Technical Service Bulletin: TSB150067

Change of Turbocharger Oil Supply Line and Routing

- QSK60 CM850 MCRS (2 Stage Versions)
- QSK60 CM2150 MCRS (2 Stage Versions)

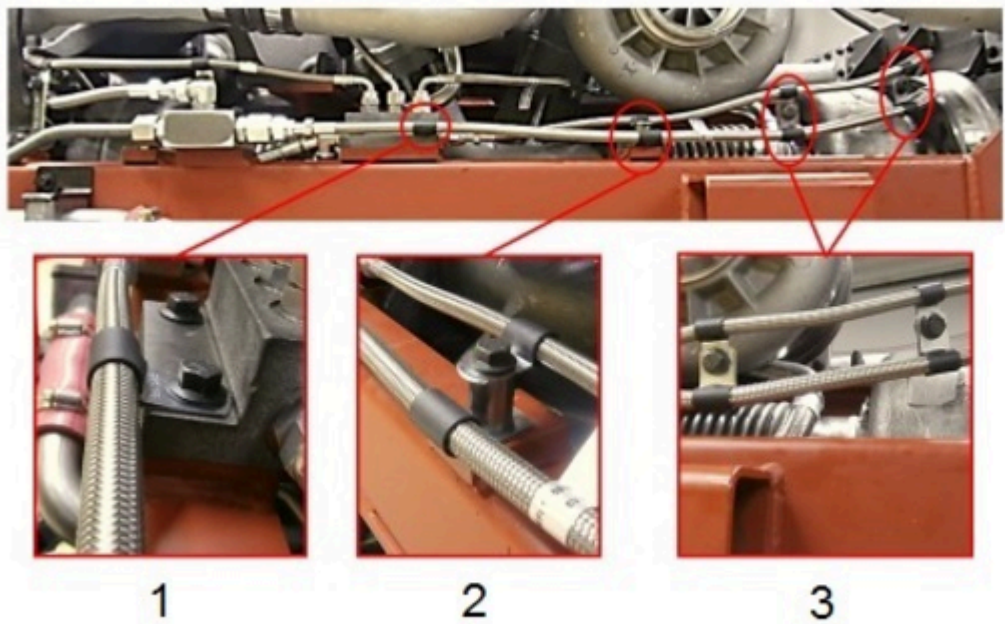
This document announces a change to the turbocharger oil supply line routing and turbocharger coolant hose routing. The revised turbocharger oil supply line and turbocharger coolant hose use additional hardware.

Improved clearance of the turbocharger oil supply line and turbocharger coolant hose from surrounding components.

Figure 1, Left Bank

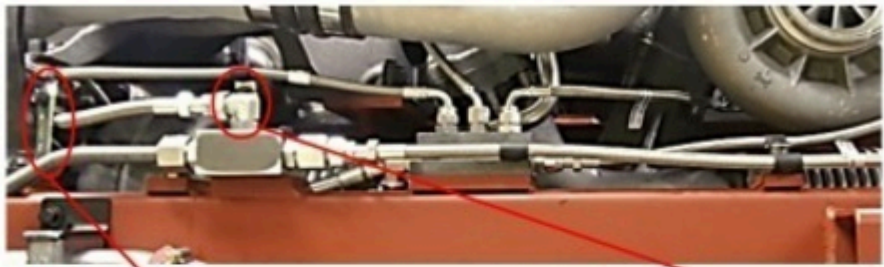
See Figure 1 and 2 for left bank installation. See Figure 3 and 4 for right bank installation.

All capscrews **must** be tightened to 45 Nm [33 ft-lb].
